RE: OSDS Plan 12958 (McDaniel Prop. "Lot 6")

OSDS Revision Comments

ONSITE SEWAGE DISPOSAL SYSTEM DESIGN PLAN

MCDANIEL PROPERTY - LOT 6
12958 HIGHLAND ROAD
HIGHLAND, MD 20777

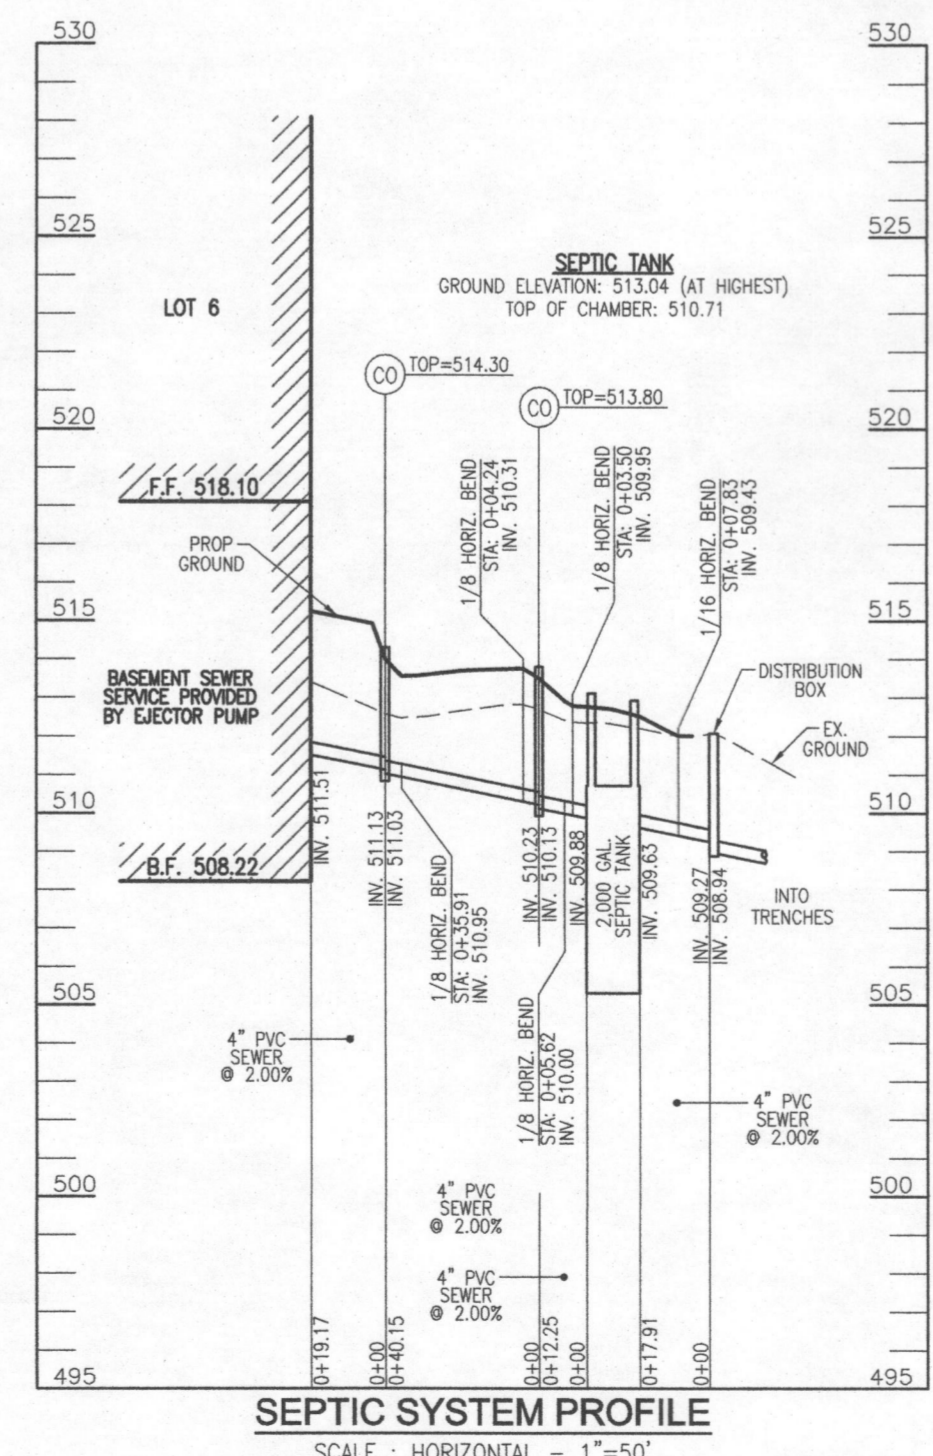
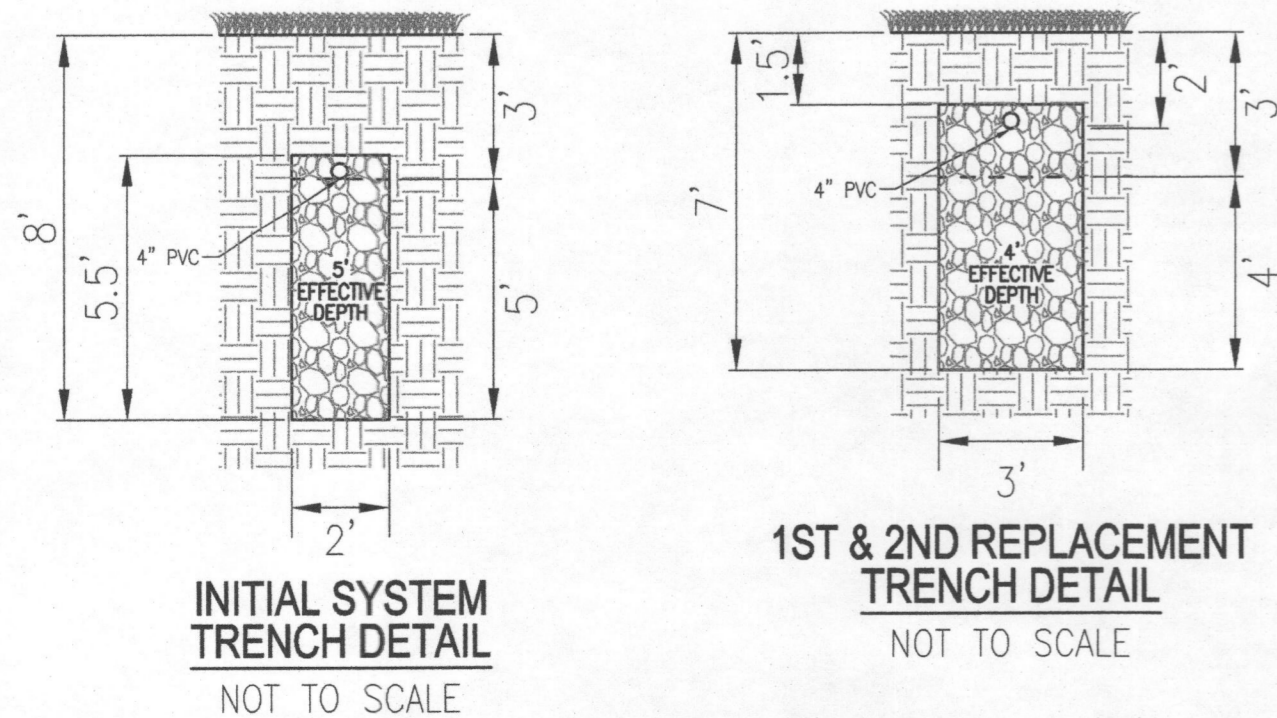
1. We need a scale 1:30 or 1:40 that focuses more on the desired property.
2. New spec sheet will alter the calculations and trench details. Those will have to be modified.
 - a. See attached.
3. Trench details need to be labeled more clearly with appropriate language.
 - a. All zones detailed.
4. Remove note #9.
5. It is suggested to remove bends, not entirely necessary for this lot.
 - a. Can get on contour better.
 - b. If you do show bends, they need to be called out with degree fitting and should be uniform through system.
